**Special Standard  
 PUD Zoning District**

**Project Name: Villages at Sterling Ranch**

**PCD File No.: PUDSP-226**

**PRIVATE ROAD (30' WIDE TRACT)**

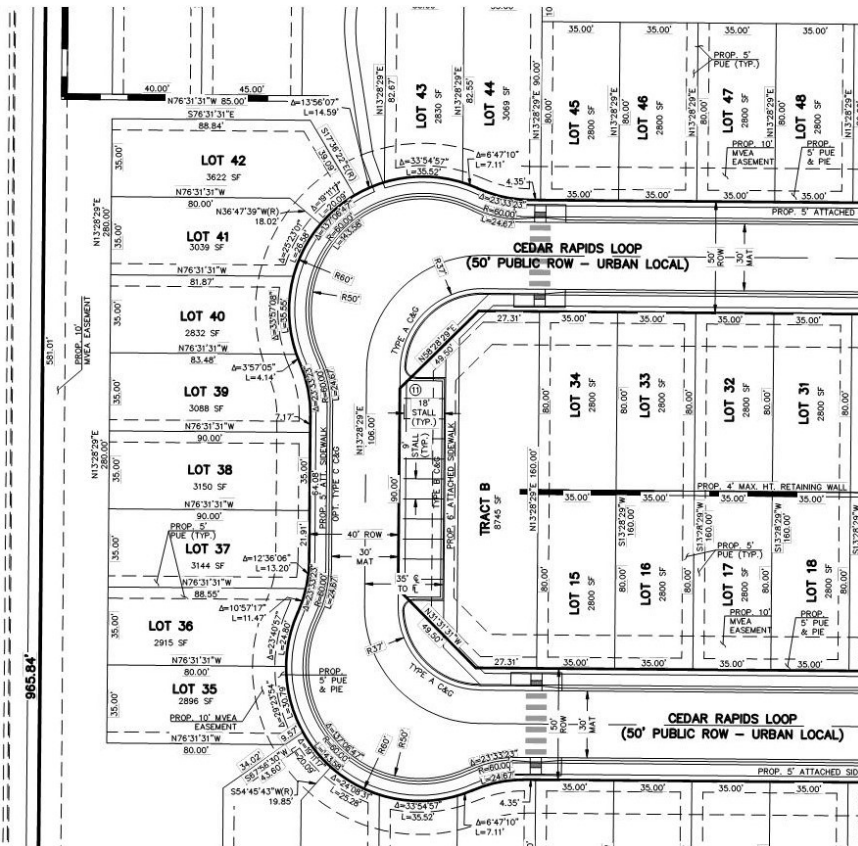
Include reference to City detail for alley

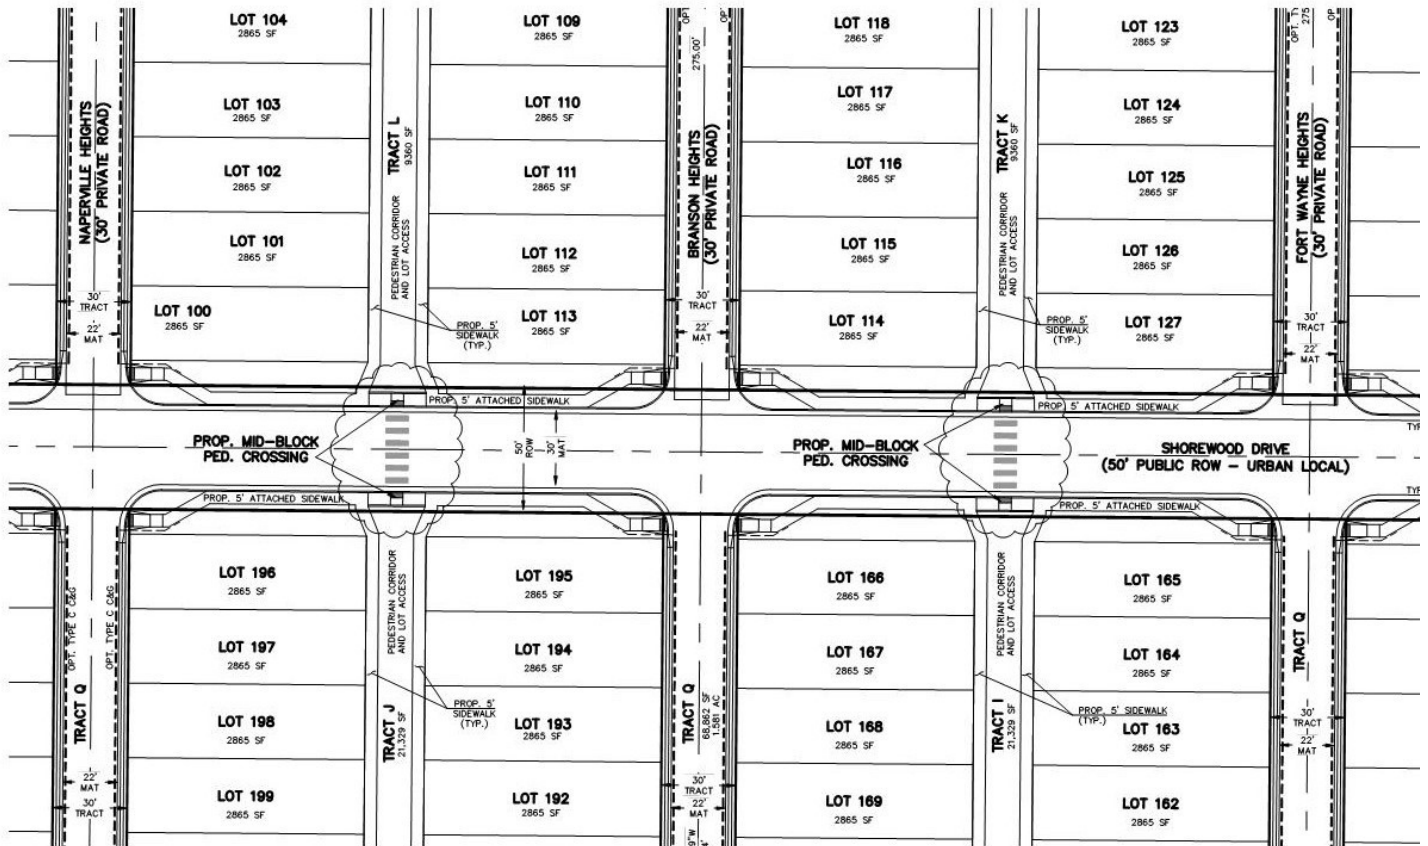
Provide exhibit for fire truck movements and letter from fire dept stating they are ok with design, if you can get it.
